REMARKS

Title: SYSTEM FOR RAPIDLY AND UNIFORMLY COOLING RESIST
Inventor(s): Ramkumar Subramanian, et al.
Serial No. 09/707,413
Docket No. E0794

Fig. 1b

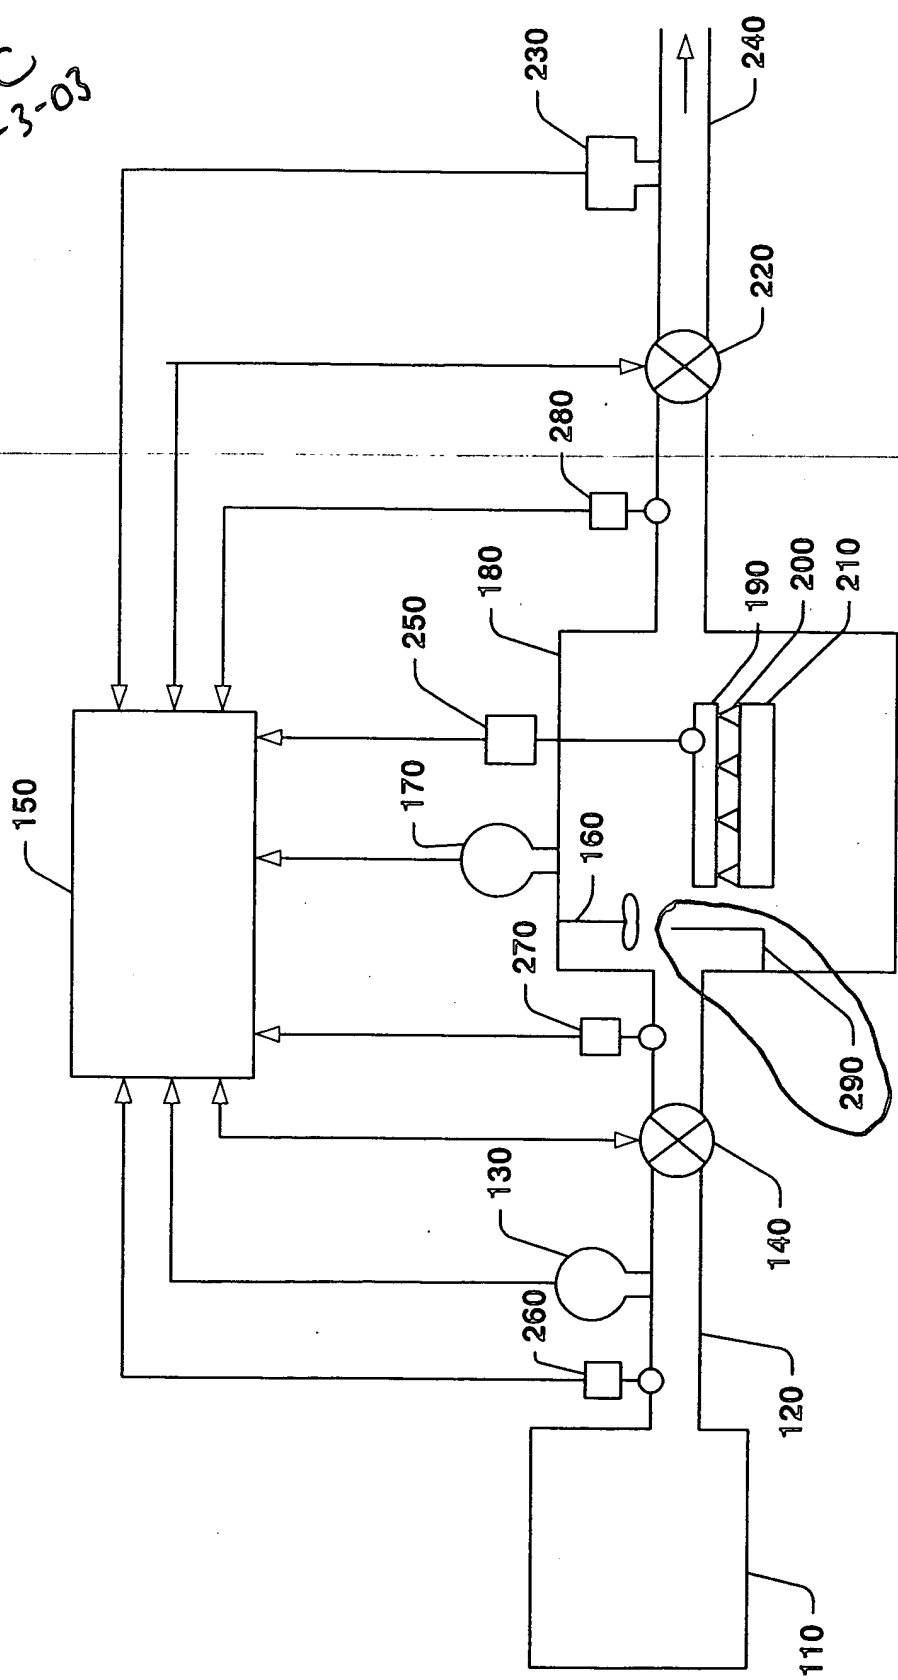
The Examiner has stated that a baffle, as recited in Claim 8, is not described in the specification. The term baffle is disclosed at page 9, line 27. Additionally, Fig.1b has been amended to show the baffle.

Approved.
ANC
1-3-03
